AMENDMENTS TO THE DRAWINGS:

REMARKS

ANNOTATED SHEET

FIG. 1

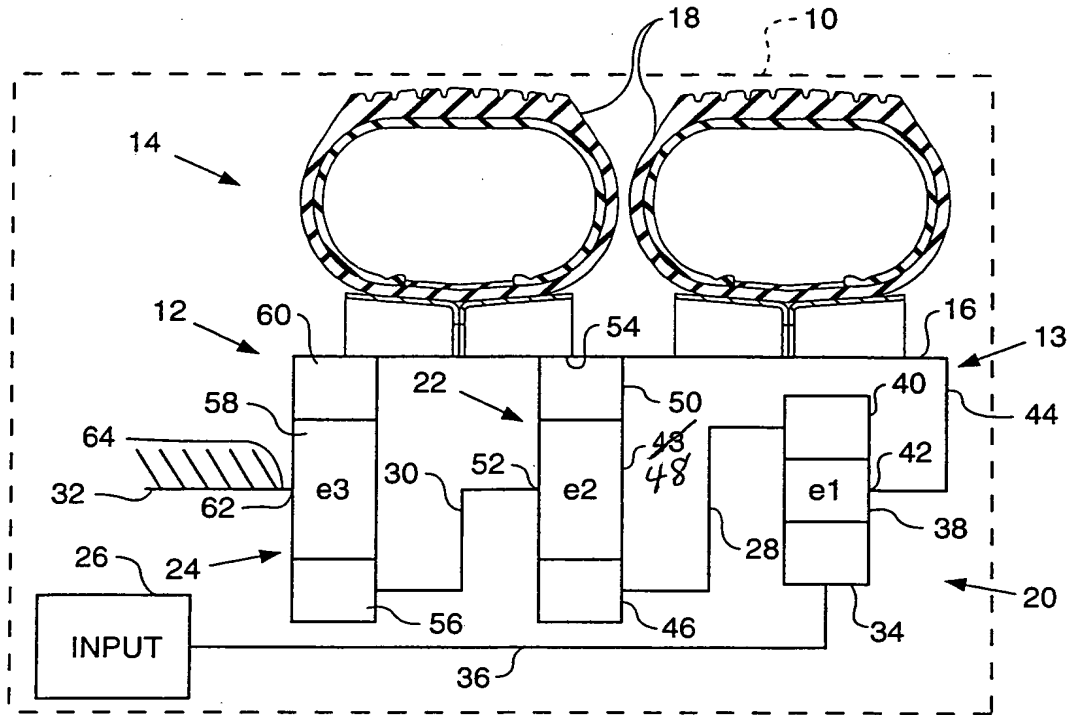
The attached sheet of drawings includes changes to correct a typographical error in Fig. 1. Reference character 43 has been replaced by reference character 48, which is set forth in the specification, e.g., paragraphs 20 and 21.
